Form 3160-5
(June 2019)

SUNDRY NOTICES AND REPORTS ON WELLS
Do not use this form for proposals to drill or to re-enter an abandoned well. Use Form 3160-3 (APD) for such proposals.

Mewbourne Oil company requests approval to make the following changes to the approved APD (30-025-53649):

OPERATOR'S NAME: MEWBOURNE OIL COMPANY
WELL NAME & NO.: BILBREY 34/27 FED COM 328H
APD ID: 10400086108
LOCATION: Section 34, T.21 S., R.32 E. NMP.
COUNTY: Lea County, New Mexico ▼

Figure 1. Cactus 13 3/8" 5M offline cementing tool. Pressure rating limited by the lesser of 5M tool rating or the 13 3/8" pup joint and casing.

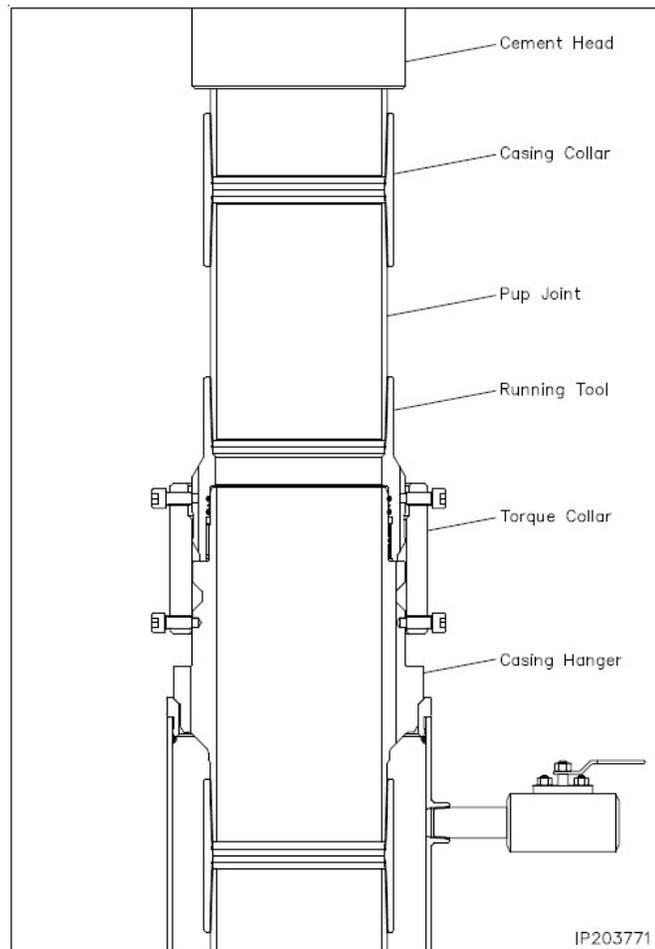
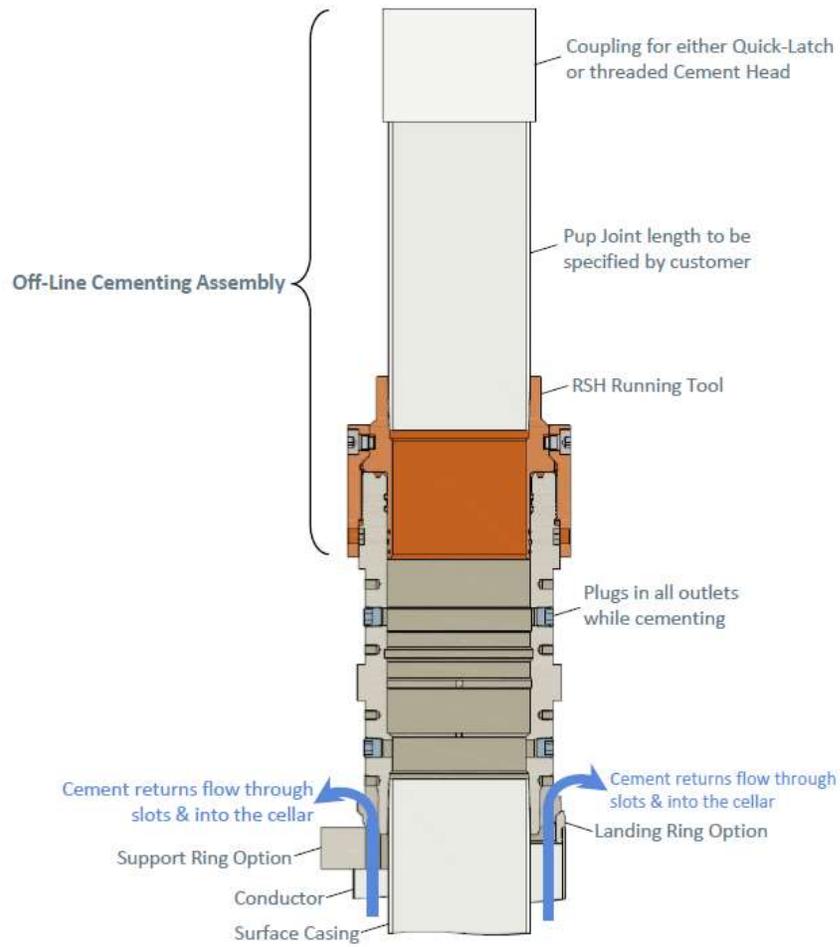
9. Make up offline cement tool with forklift per wellhead manufacturer (Fig. 1 & 2).
10. Make up cement head on top of offline cement tool with forklift.

Figure 3. Cactus 9 5/8" 5M offline cementing tool. Pressure rating limited by the lesser of 5M tool rating or the 9 5/8" pup joint and casing.

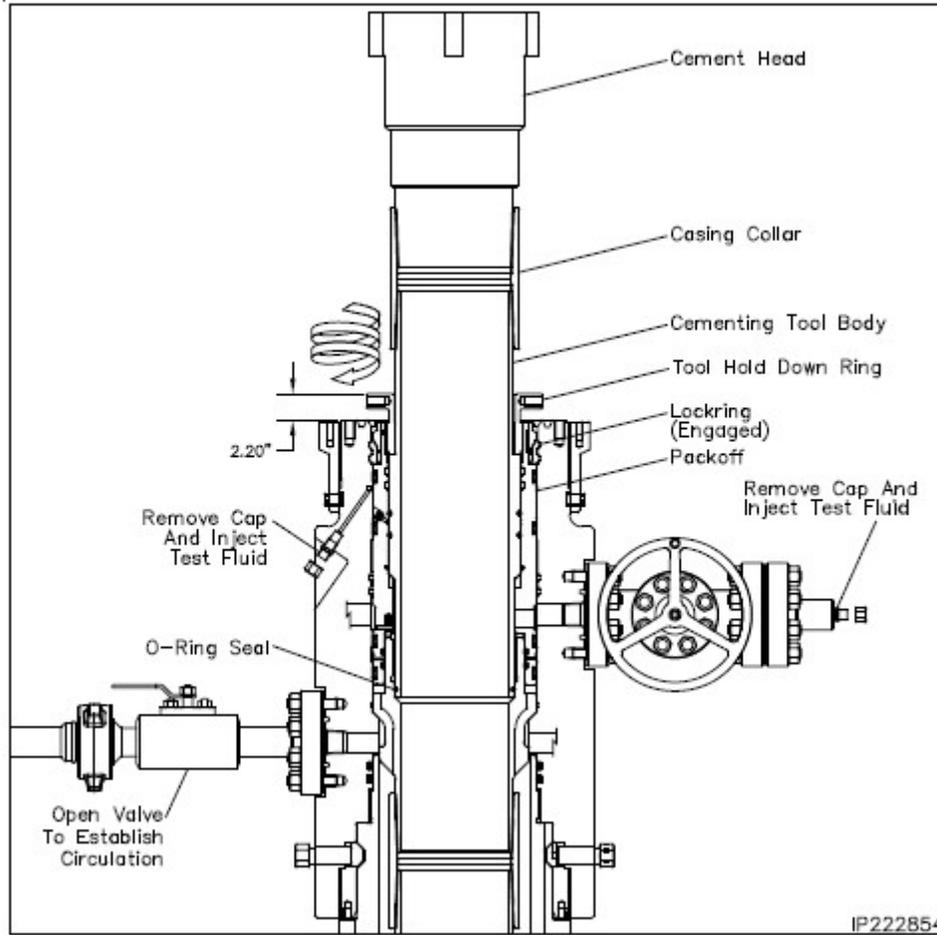
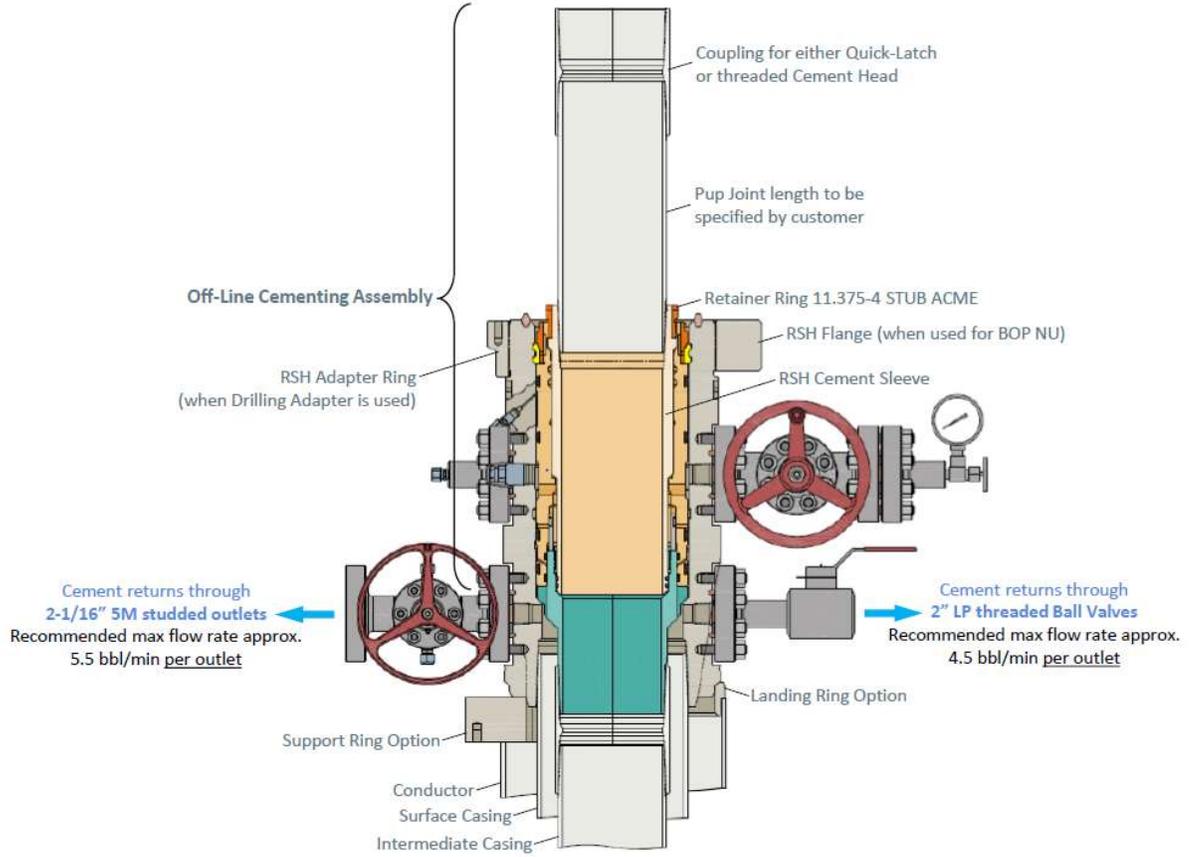
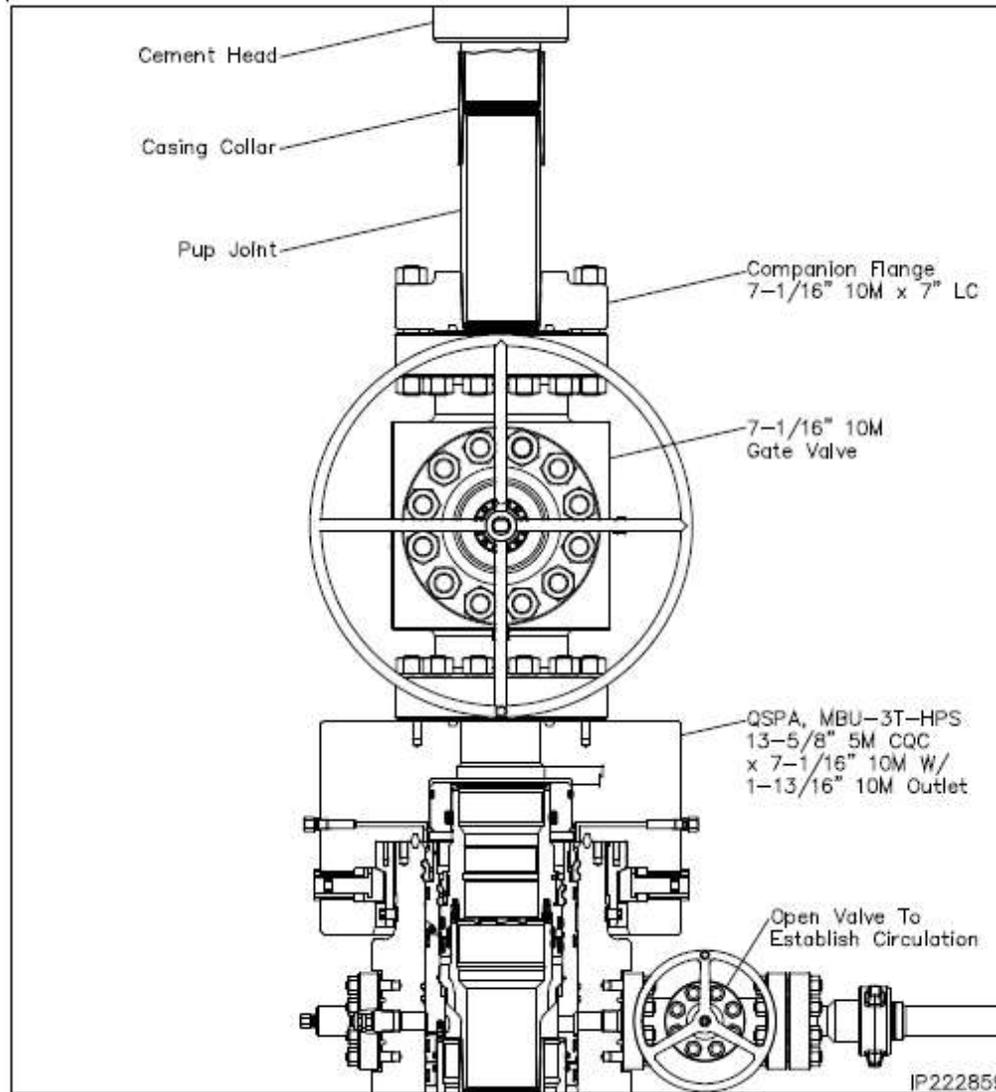
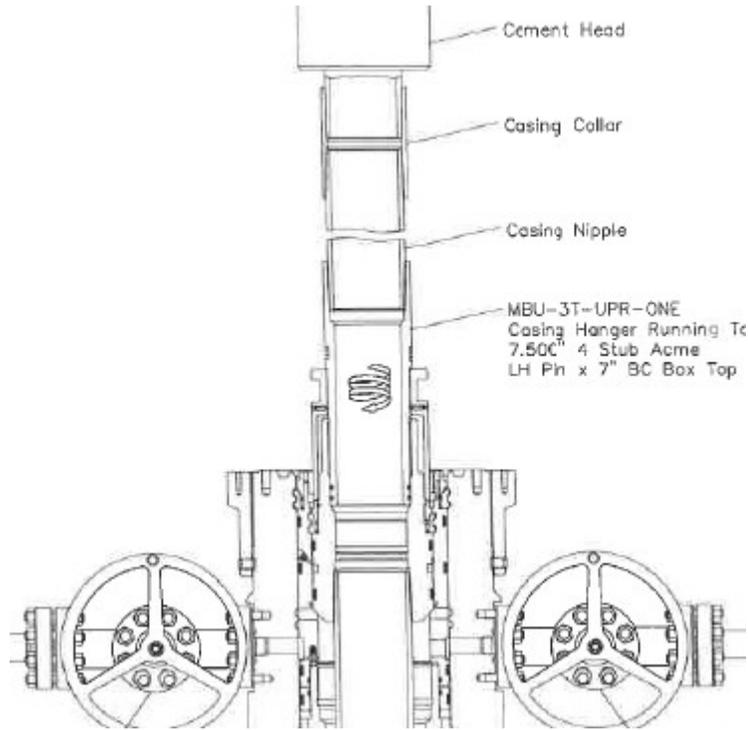
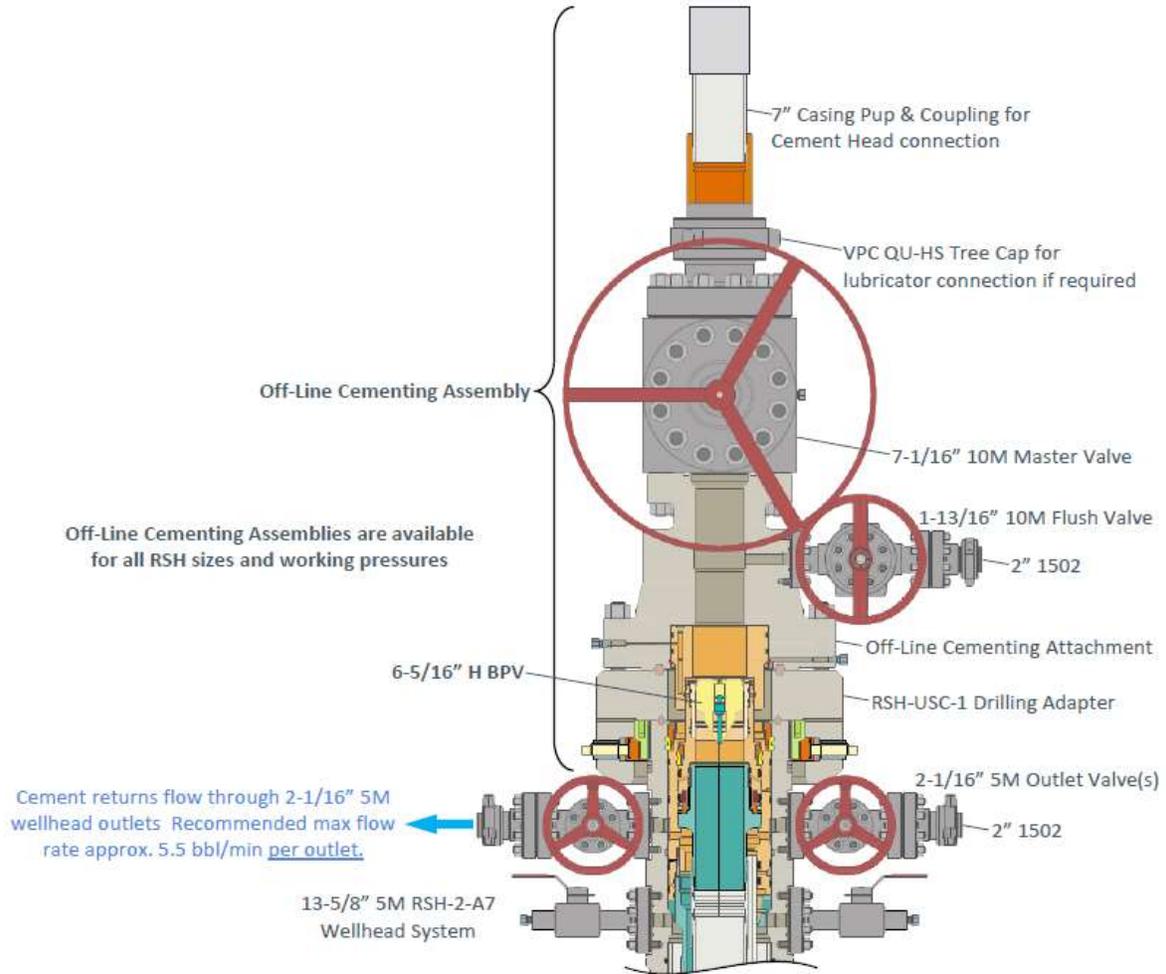
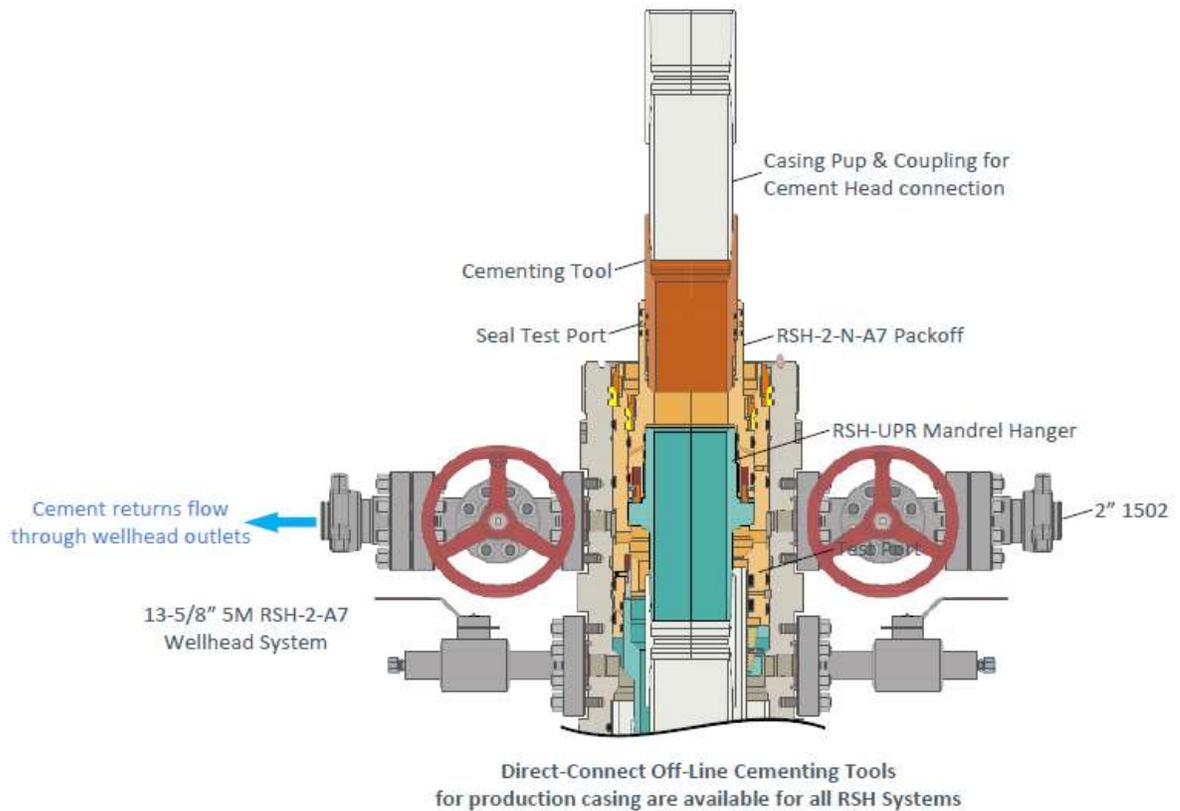
10. Make up offline cement tool using forklift per wellhead manufacturer (Fig. 3 - 8).
11. Make up cement head on top of offline cement tool.
12. Commence cement operations.

Figure 1. BOP diagram

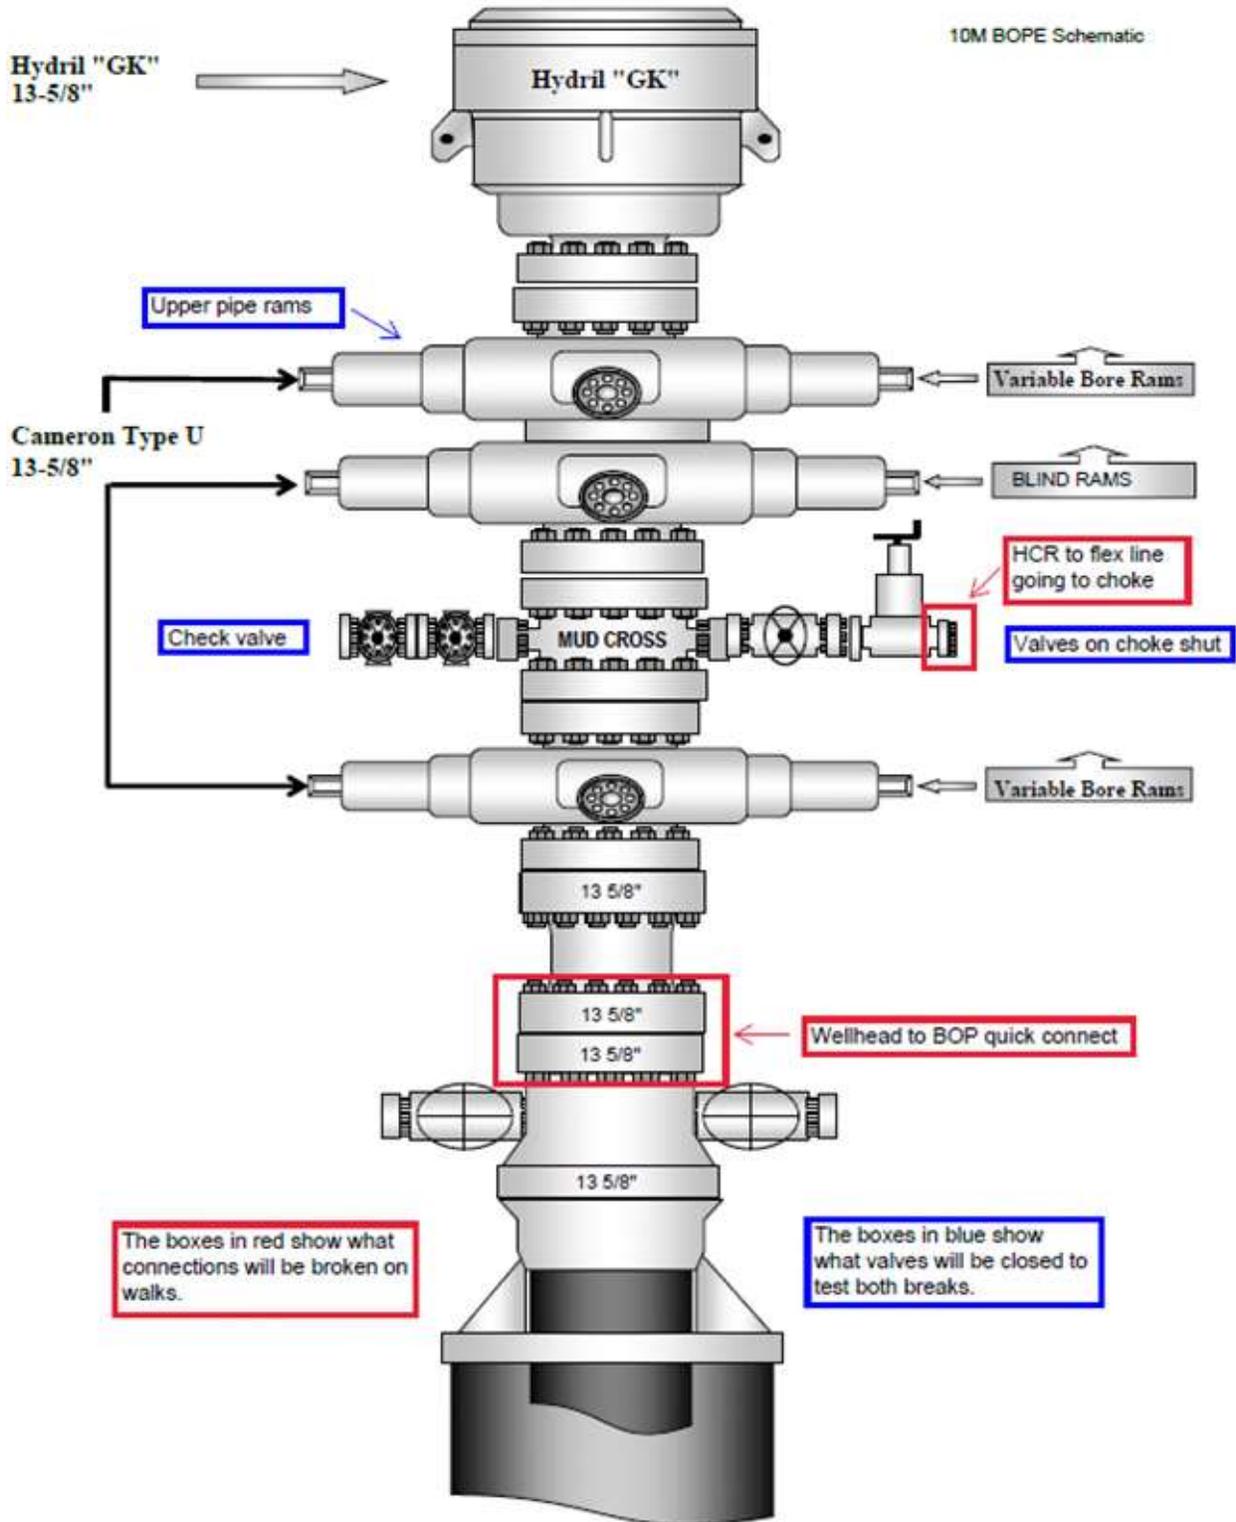
2. After the well section is secured and the well is confirmed to be static, the BOP will be disconnected from the wellhead and walked with the rig to another well on the pad. Two breaks on the BOPE will be made (Fig. 1).

9. A test will then be conducted against the upper pipe rams and choke, testing both breaks (Fig. 1 & 2).
10. The test will be held at 250 psi low and to the high value submitted in the APD, not to exceed 5000 psi.

Figure 5. Cactus 5M wellhead with BOP quick connect

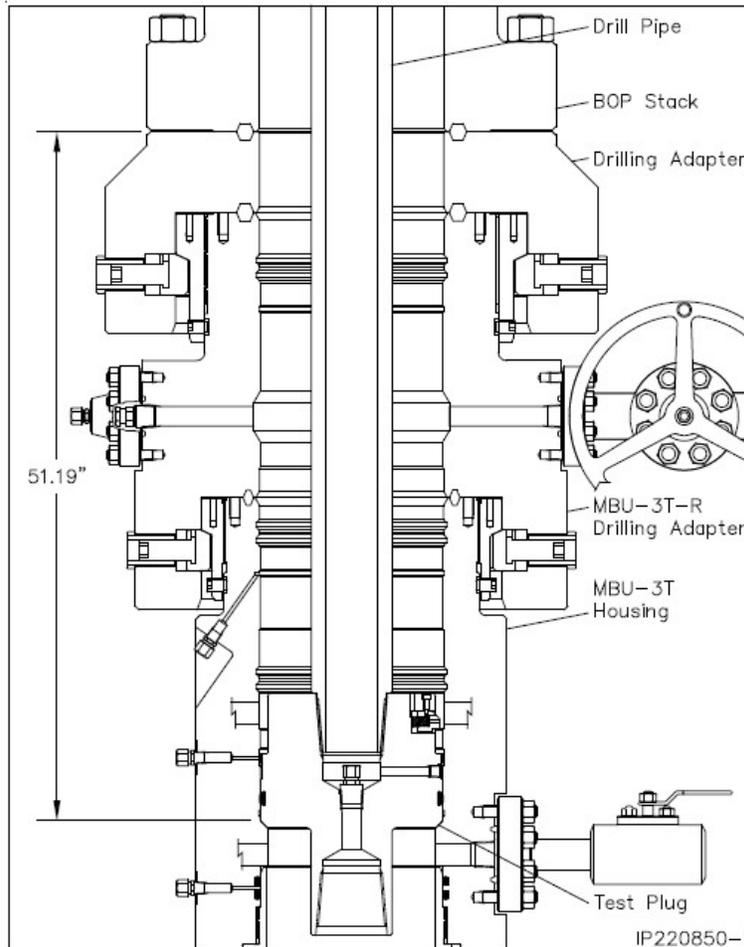
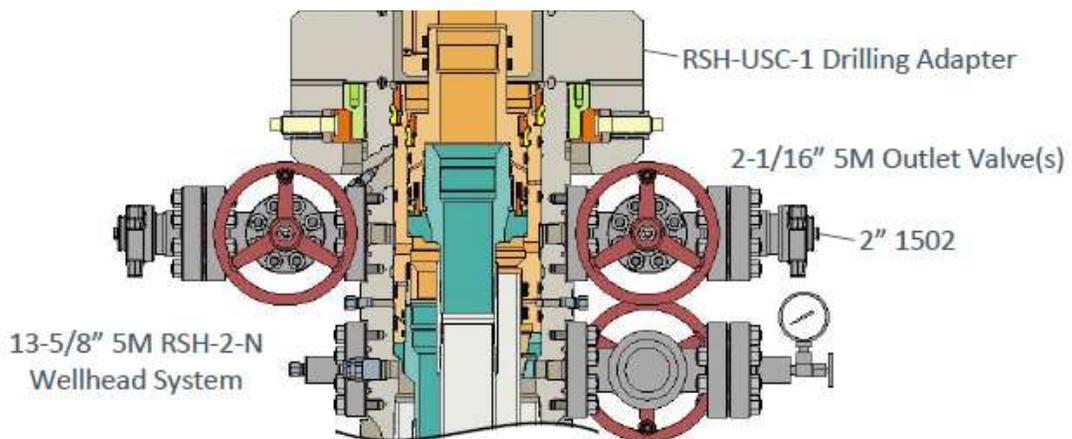
- Connection between the flex line and the HCR valve
 - Connection between the wellhead and the BOP quick connect (Fig. 5 & 6).
3. A capping flange will be installed after cementing per wellhead vendor procedure & casing pressure will be monitored via wellhead valve.
